DOCKETED	
Docket Number:	18-IEPR-03
Project Title:	Southern California Energy Reliability
TN #:	224031
Document Title:	Porter Ranch Neighborhood Council Letter to Ed Randolph at the CPUC Regarding the Draft 715 Report
Description:	N/A
Filer:	Stephanie Bailey
Organization:	Porter Ranch Neighborhood Council (PRNC)
Submitter Role:	Public
Submission Date:	7/2/2018 1:12:34 PM
Docketed Date:	7/2/2018

Re: Comments on Draft 715 Report issued on June 18, 2018¹

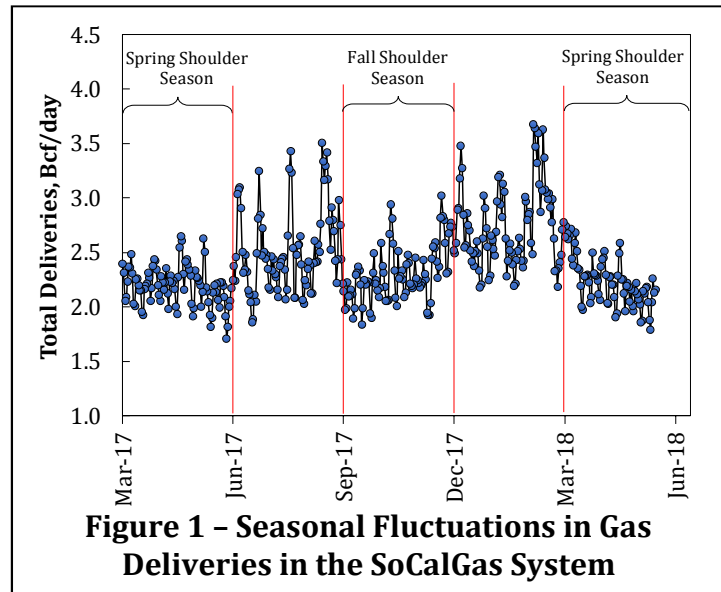
there is absolutely no reason to do that before the summer season begins. The 715 Report notes the CPUC's desire to take advantage of the low demand during this spring shoulder season. We wish to remind the CPUC that there is also a fall shoulder season with equally low gas demand. Figure 1 is a profile of the seasonal fluctuations in gas deliveries in the SoCalGas system since March 2017. Just like this spring shoulder season replicates the 2017 spring shoulder season, there will be another low-demand shoulder in the fall season. At the start of that season, the CPUC will have more reliable information about the storage inventory at that time and will know if SoCalGas has done its job of fixing its failed transmission system resulting in a more informed decision about Aliso storage needs. If it determines then that additional gas needs to be stored in Aliso, the CPUC will still have sufficient time to instruct SoCalGas to achieve the inventory target before the start of the winter season.

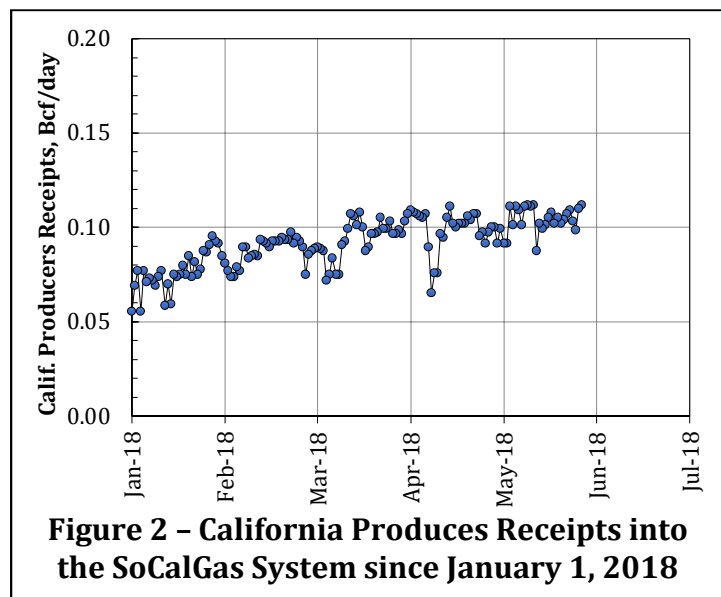
In making the calculations in the attached tables, we increased the California Producers (CP) deliveries from the 60 MMcfd value assumed in the draft 715 Report to 100 MMcfd based on the ENVOY data as shown in Figure 2. The data demonstrate that, when SoCalGas asks for more than 60 MMcfd, it gets it. Since March of this year, the CP receipts have been, and continue to be, at or above 100 MMcfd. Based on these data, there is no reason to keep the CP receipts value at 60 MMcfd in the 715 Report calculations.
